Item Name: Crosstube Turning Detail

DRAWING NO. D407-667-145	TITLE CROSSTUBE ASS'Y (407 HIGH FWD)	REV. C	DART AEROSPACE LTD ENGINEERING ORDER		D.E.O. NO. D407-667-145-C-1	SHEET NO. SHEET 1 OF 1	SCALE NTS
DRAWN 9	CHECKED 155	MFG. APPR. 155	APPROVED 155		DE APPR. 155		
DATE 11.07.15	DATE 11.07.22	DATE 11.07.22	DATE 11/07/22		DATE 11.07.21

DRAWING NO. D407-667-145	TITLE CROSSTUBE ASS'Y (407 HIGH FWD)	REV. C	DART AEROSPACE LTD ENGINEERING ORDER		D.E.O. NO. D407-667-145-C-2	SHEET NO. SHEET 1 OF 1	SCALE NTS
DRAWN AJS	CHECKED	MFG. APPR.	APPROVED	DE APPR.	DATE	DATE	DATE
DATE 12.08.02	DATE 12.08.02	DATE 12.08.02	DATE 12.08.02	DATE 12.08.02	DATE 12.08.02	DATE 12.08.02	DATE 12.08.02

DETAIL P
BONDING STRAP INSTALLATION 2 PL

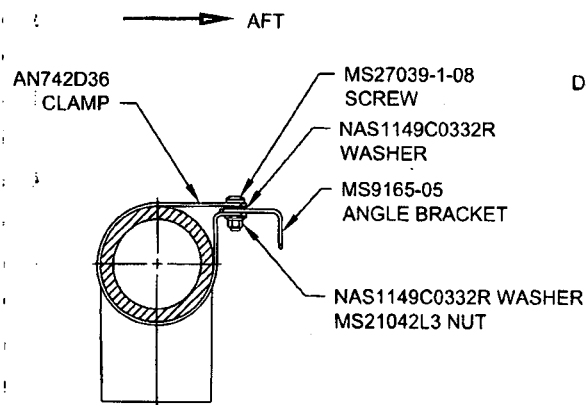
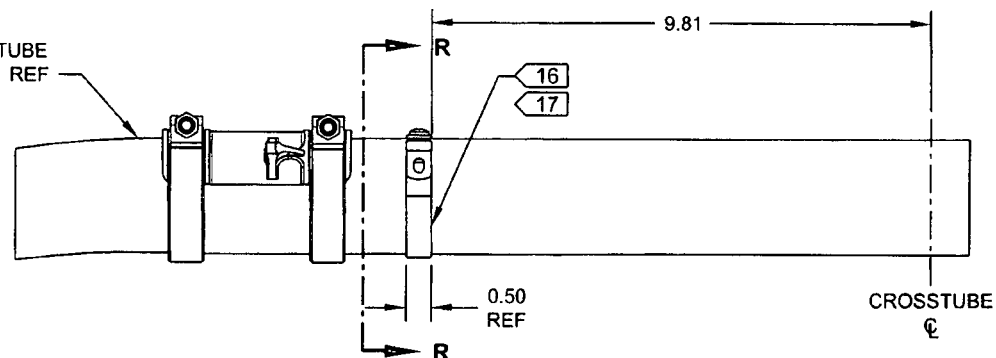
ADD ELECTRICAL GROUNDING STRAP

ITEM	QTY -145	PART NUMBER	DESCRIPTION
1	X	D407-667-145	CROSSTUBE ASSEMBLY (407 HIGH FWD)
10	2	AN742D36	CLAMP
11	2	MS9165-05	ANGLE BRACKET
12	2	MS21042L3	NUT (OR MS21042-3)
13	2	MS27039-1-08	SCREW
14	4	NAS1149C0332R	WASHER (OR AN960C10L)

- 16) MASK AREA UNDER CLAMP PRIOR TO PAINTING
- 17) SEAL EDGES WHERE AN742D36 CLAMP MEETS WITH THE CROSSTUBE USING SIKAFLEX-241/-291 OR MIL-S-8802 CLASS B2 OR PROSEAL 890 SEALANT
- 18) PERFORM RESISTANCE CHECK TO ENSURE MAX RESISTANCE IS 10 MILLIOHMS
